| Stage 6: Final Modification Report | | At what stage is this document in the process? | | | | | | | | | | | | |
|--|---|--|----|---------------|----|------------------------|----|------------------|----|--|----|---------------------------------|----|---------------------------|
| <h1 style="color: #00a651;">GC0096</h1> <h2 style="color: #00a651;">Modification Title: Energy Storage</h2> |

1 About this document

GC0096 was proposed by National Grid Electricity System Operator (NGESO) and was submitted to the Grid Code Review Panel for its consideration on May 2016. The Panel decided to send the Proposal to a Workgroup to be developed and assessed against the Grid Code Applicable Objectives.

Figure 2.0

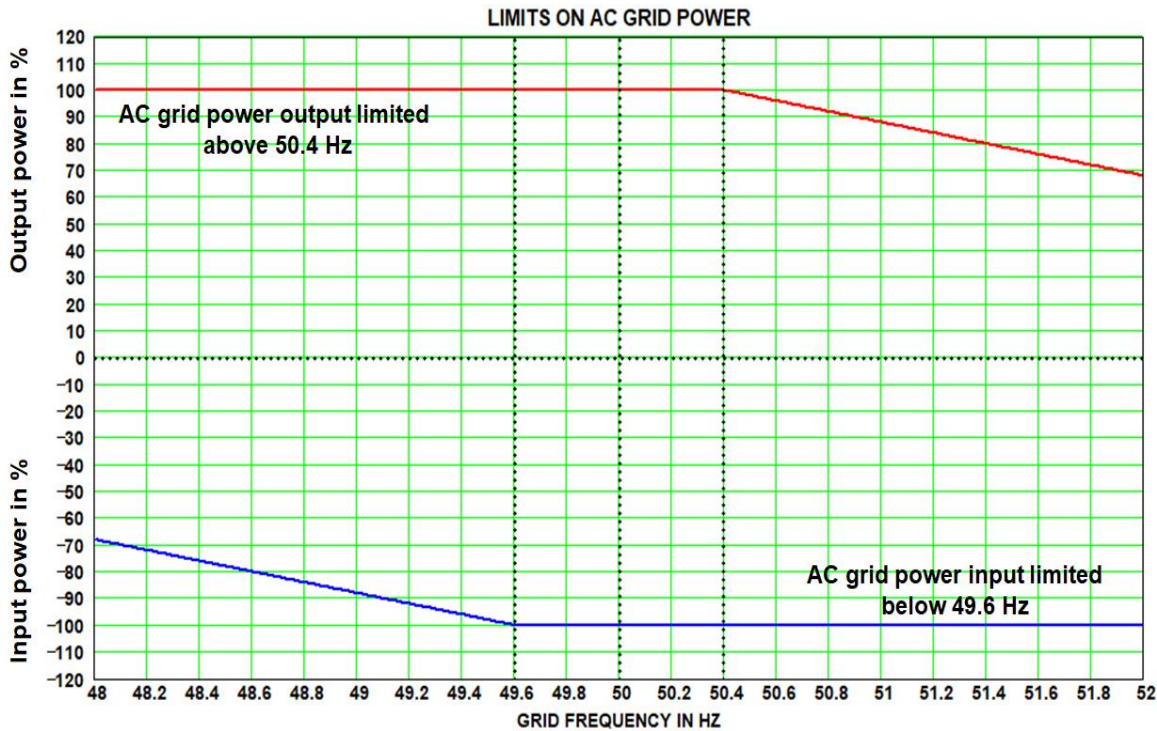
As part of the Workgroup discussions, one Workgroup member noted that storage should have a requirement to cater for limiting power input with falling frequency and limiting power output with rising frequency and proposed the use of the following graph.

The Proposer would however note that the characteristic shown in Figure 2.0 may be more appropriate however as also pointed out by a workgroup member this requirement applies to generation equally as it applies to Storage. As such, and as the aim of the workgroup is to ensure consistent treatment between different classes of User's, this is an issue that should be highlighted as a future area of work as the implications of a change to generation affects a much greater audience.

In addition, the Proposer would note that as part of the GC0096 proposals, that when a storage element is operating in a condition analogous to demand, then there is a requirement for this demand to be reduced as frequency falls as defined under OC6.6, in just the same way as pump tripping as part of a pumped storage plant.

Figure 3.0 (a)

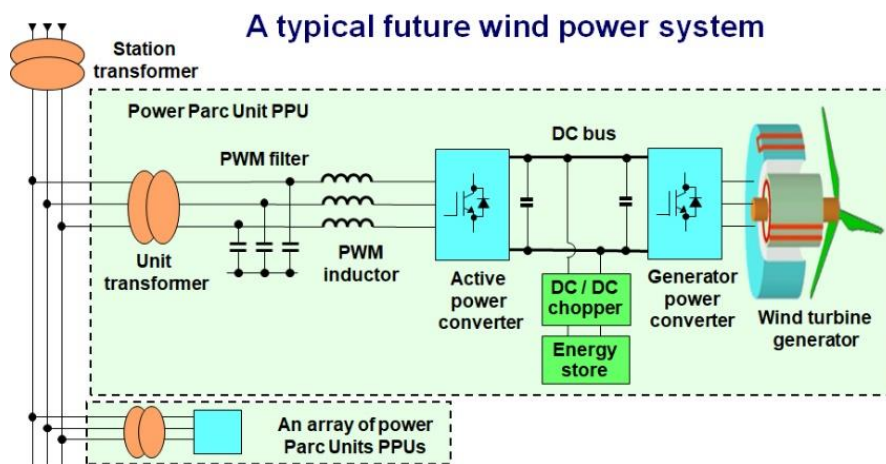
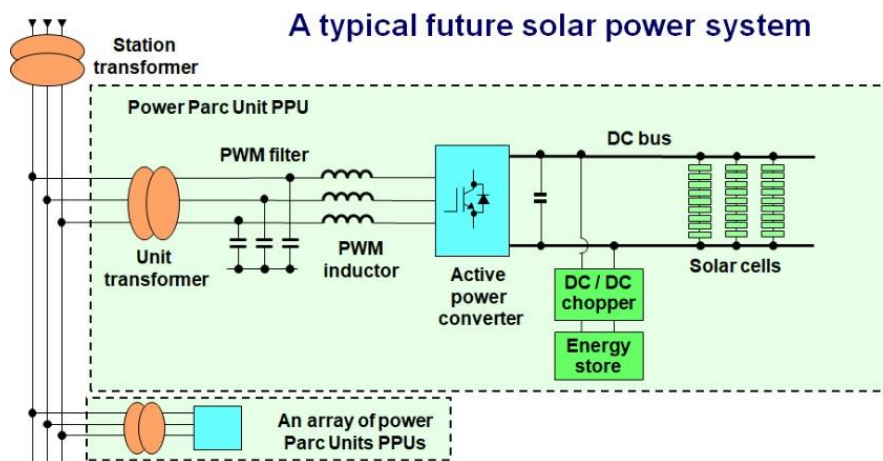
In addition, a Workgroup Member noted that as part of a future co-located site that it was entirely likely that an energy storage technology could be integrated as part of a solar park, wind farm or synchronous plant. Figure 3.0(a) and Figure 3.0(b) below (which have been re-produced in this report with the kind permission of ENTSO-E) illustrate this example for a wind farm or solar park.

One Workgroup member noted that for wind farms and solar parks, the storage elements are not directly connected to the AC system and raised concern that they would not be required to satisfy the requirements of the GC0096 proposals. It was also noted that for rotating synchronous generators this is not so much of an issue.

In response, the Proposer would note that where you have a Power Station comprising of Power Park Modules and/or Electricity Storage Modules, the Grid Code applies to the Power Park Modules and Electricity Storage Modules within that Power Station.
